Replacement of T9 Pump

The previous pump **(TL-B11-220012)** used in the T9 from Insatech has been discontinued. Going forward a new pump **(TL-B10-A12-0905-W-07150)** is replacing it.

New Pump	Old Pump

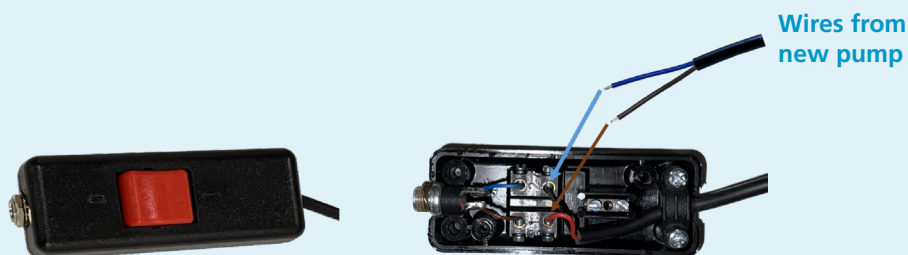
1× Custom adapter – To handle the smaller inlet tube on the new pump an adapter has to be placed in the original pump fixture as seen below.

1× Silicone hose – The outlet tube of the new pump is located further away.

2× strips – To clamp both ends of the silicone hose.

Part no.: 10372-3503-P2074, Length: 25 mm, Diameter: 33.2 mm, Hole diameter: 18 mm.

Part no.: 228-1524, Length: 220 mm, Diameter: 16 mm, Hole diameter: 10 mm.

The on/off switch can be reused by removing the wires from the old pump and connecting the wires from the new pump. For safety reasons please disconnect the power supply.
